Our Case Number: ABP-317660-23

Re: Bus Connects Kimmage to City Centre core bus corridor scheme

Bus Connects Dublin - Kimmage to City Centre Core Bus Corridor Scheme LA Road Development - Application

Bord Pleanála Case reference: HA29N.317660

Programme Title BUSCONNECTS DUBLIN CORE BUS CORRIDORS INFRASTRUCTURE WORKS						
Drawing Title KIMMAGE TO CITY CENTRE CORE BUS	CORRIDOR SC	НЕМЕ				
PAVEMENT TREATMENT	PLANS					
Drawing File Name BCIDD-ROT-PAV_PV-0011_XX_00-DR-CR-0004	Sheet Number 04 of 14	Status A	Rev M01

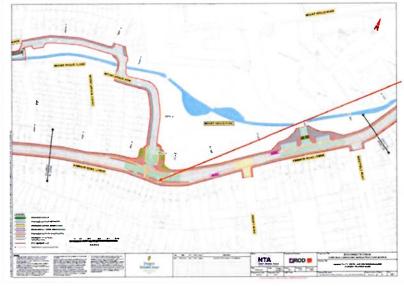
The introduction of raised pavements along this section of Lower Kimmage Road appears to be random and sporadic and there is no discernible reason as to why they are placed at these specific positions. Their presence does however lead to problems and any notional benefits are outweighed by those problems.

The introduction of raised pavements along this section of Lower Kimmage Road appears to be random and sporadic and there is no discernible reason as to why they are placed at these positions. Their presence does however lead to problems and any notional benefits are outwelghed by those problems:

- The gap between these proposed two (raised) pavements is too narrow to allow for unencumbered access and egress to and from the lane which is used for vehicular rear access for up to c.28 properties*, with that lane being the ONLY FRONT and PRIMARY vehicular (and home occupants) access for properties 128D and 128E kimmage Road Lower. This obstruction means that vehicles will not have enough room to turn into and out of the lane and it will lead to those vehicles having driving into oncoming traffic.
 It will create difficulties for Waste removal companies servicing properties numbered from 128 to 136

- It will create difficulties for Waste removal companies servicing properties numbered from 128 to 136
 Kimmage Road Lower and will result in emptied bins being further strewn along the road. This practice (of
 not placing bins immediately outside of owning property) WILL be exasperated, leading to pedestrian and
 possibly cyclists movement obstruction.

Design amendment required: the proposed raised pavements in front of numbers 126 to 136 Kimmage Road Lower should be removed. Should any alternative structures be proposed, then they too MUST NOT give rise to the above identified problems.

Programme Title BUSCONNECTS DUBLIN CORE BUS CORRIDORS INFRASTRUCTURE WORKS						
Drawing Title KIMMAGE TO CITY CENTRE CORE BUS TRAFFIC SIGNS & ROAD M		HEME				
Drawing File Name BCIDD-ROT-TSM_GA-0011_XX_00-DR-CR-0004	Sheet Number 04 of 14	Status A	Rev M01

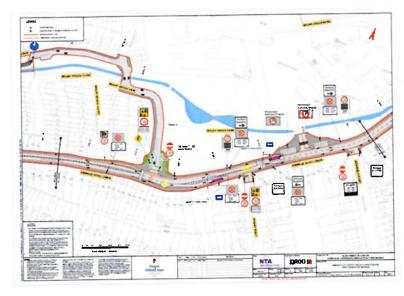
Road markings – provision for and maintenance of lane vehicular access: This scheme drawing appears to suggest that allowance has been made for vehicular access and egress of the indicated lane – should the scheme be approved, this MUST be retained; if the Road markings do not currently cater for that unencumbered access and egress then it SHOULD do so.

Note: This lane is used for vehicular rear access for up to c.28 properties*, with that lane being the ONLY FRONT and PRIMARY vehicular (and home occupants) access for properties 128D and 128E Kimmage Road Lower.

I request that any road markings and traffic signage provide for the unencumbered access and egress to the lane between 128C and 130 Kimmage Road Lower.

Programme Title BUSCONNECTS D CORE BUS CORRIDORS INFRAS		WORK	s
Drawing Title			
KIMMAGE TO CITY CENTRE CORE BUS		HEME	
GENERAL ARRANGEN	MENT		
Drawing File Name	Sheet Number	Status	Rev
BCIDD-ROT-GEO_GA-0011_XX_00-DR-CR-0004	04 of 14	Α	M01

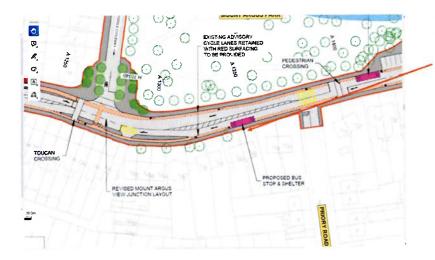
Bus Stop number 2391 - Shelter located at Priory Road - OBJECTION:

The proposed introduction of this Bus shelter is impractical due to the narrow width of the pavement at this location. Its introduction will lead to obstruction of movement of pedestrians including those using mobility vehicles and buggles.

I request that the developers are instructed not to proceed with plans to build a bus shelter at this location
